# Sundry Print Report

Well Name: COTTON DRAW UNIT Well Location: T24S / R31E / SEC 25 / County or Parish/State: EDDY /

# **Notice of Intent**

Type of Action: APD Change

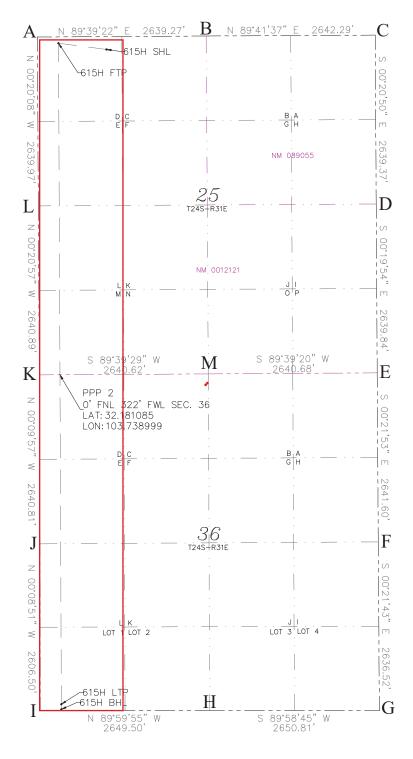
**Procedure Description:** Devon Energy Production Co., L.P. (Devon) respectfully requests to change the BHL, casing design, and spacing changes on the subject well. Devon also requests a break test and offline cementing variance. New leases have been added since approved APD and notification has been given. Please see attached revised C102, Drill plan, directional plan, spec sheets, break test and offline cementing variance. Permitted BHL: SWSW, 20 FSL, 990 FWL, 25-24S-31E Proposed BHL: LOT 1, 20 FNL, 330 FWL, 36-24S-31E

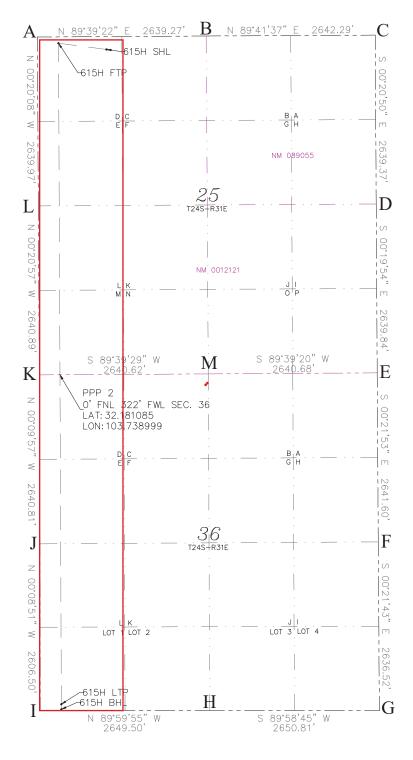
Procedure Description: Devon Energy Production Co., L.P. (Devon) respectfully requests to change the BHL, casing design, and spacing changes on the subject well. Devon also requests a break test and offline cementing variance. New leases have been added since approved APD and notification has been given. Please see attached revised C102, Drill plan, directional plan, spec sheets, break test and offline cementing variance. Permitted BHL: SWSW, 20 FSL, 990 FWL, 25-24S-31E Proposed BHL: LOT 1, 20 FNL, 330 FWL, 36-24S-31E
